UNITED STATES PATENT AND TRADEMARK OFFICE

APPLICATION NO.	FILING DATE	FIRST NAMED INVENTOR	ATTORNEY DOCKET NO.	CONFIRMATION NO.
10/580,585	12/20/2006	Laurent Dubedout	291613US6PCT	5553
22850 7590 02/08/2010 OBLON, SPIVAK, MCCLELLAND MAIER & NEUSTADT, L.L.P. 1940 DUKE STREET ALEXANDRIA, VA 22314				
EXAMINER WILLIAMS, ROBERT H.				
ART UNIT 3679		PAPER NUMBER		
NOTIFICATION DATE 02/08/2010		DELIVERY MODE ELECTRONIC

Office Action Summary

DETAILED ACTION

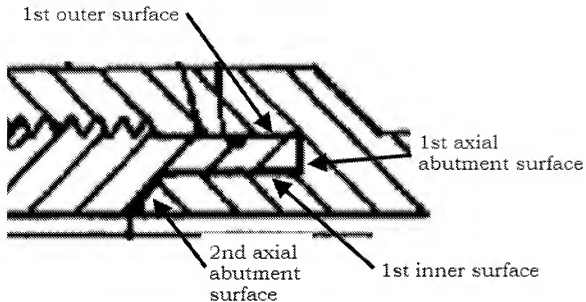
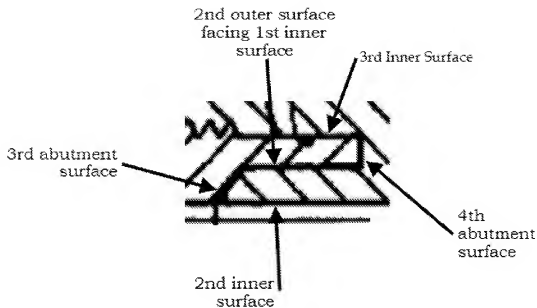
16. Regarding claim 1, Metcalfe '947 discloses an assembly of two expandable threaded tubular joints, disposed symmetrically (page 8, lines 11-21, "The assembly ... allows lengths of expandable tubing to be connected to form a string, [and] comprises a tubular connector ... utilized to join the ends of two lengths of expandable tubing," Fig. 2, #20, 21, 24, 25) and each comprising,

a first tubular element arranged at an end of a tube and comprising a first portion, provided with a male thread (page 9, line 3, "threads on the outer surface of the tubing," Fig. 2 #24, 28), and a second portion extending said first portion (page 9, lines 3-4, "Inwardly of the threads, the end portions," Fig. 2 #20, 21) and comprising:

- i) a first outer surface,
- ii) a first annular lip having a first axial abutment surface and a first inner surface and delimited by said first outer surface over a portion of the axial length thereof, and
- iii) a second abutment surface (page 9, lines 5-6, "corresponding tongues provided on the ends of the tubing lengths," Fig. 2 #32, and as shown below);

- i) a female thread, matching the first male thread and screwed thereto (page 9, lines 1-3, "inner walls of each connector end portion define threads for engaging corresponding threads on the outer surface of the tubing," Fig. 2 #26, 27),
- ii) a second annular lip, having a third abutment surface, a second outer surface, configured to be arranged to face said first inner surface, and a second inner surface, and wherein
- iii) a third inner surface and a fourth axial abutment surface defining with the second outer surface an annular recess matching and receiving the corresponding first lip (Fig. 2, as shown below),

wherein said second tubular elements form two opposing ends of a female/female-type connection sleeve (page 8, line 14, "tubular connector," Fig. 2 #16), separated by a central portion (page 8, lines 17-18, "intermediate portion," Fig. 2 #22) initially provided, over an outer surface, with an annular zone having an initial reduced thickness (page 8, lines 26-28, "the connector end portions are upset, that is they include portions of greater wall thickness than the tubing and are of a greater diameter than the tubing," Fig. 2) and each second abutment surface rests against the corresponding third abutment surface and/or in that each abutment surface rests against the corresponding fourth abutment surface (Fig. 2, and as shown above), and

wherein the assembly is configured to develop, after diametral expansion in the plastic deformation region, sealing interference contacts sealing the assembly (where the first tubular element, 24, of Metcalfe '947 is sealed to the second tubular element, 20, by the interengagement of their threads, 26 and 28, and of their tongue, 30, and groove, 32).

18. Regarding claim 16, Metcalfe '947, as applied to claim 1 above, further discloses a first outer surface and third inner surface are shaped in such a way that, after expansion, a sealing interference contact is defined between a portion of each of them (see the annotated Fig. 2, above).

19. Regarding claim 17, Metcalfe '947, as applied to claim 1 above, further discloses a first and second expandable tubular elements shaped in such a way that, after said expansion, a sealing interference contact is defined between an inner end portion of said first lip and said second outer surface (see the annotated Fig. 2, above).

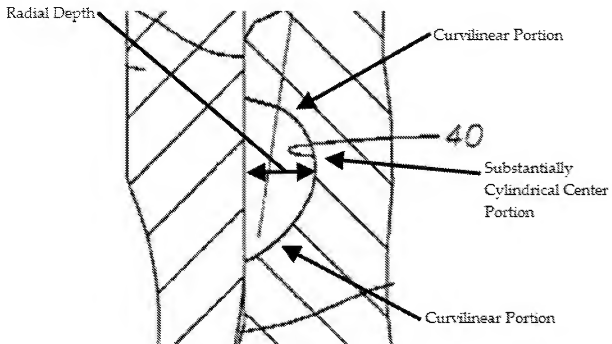
28. Regarding claims 7, 8, 10, and 11, the combination of Metcalfe '947 and Pallini '344, as applied to claim 6 above, further discloses said groove initially comprises at

least two curvilinear portions (Pallini '344, as shown in the annotated Fig. 3 below, where the radii of the curvilinear portions are substantially identical).
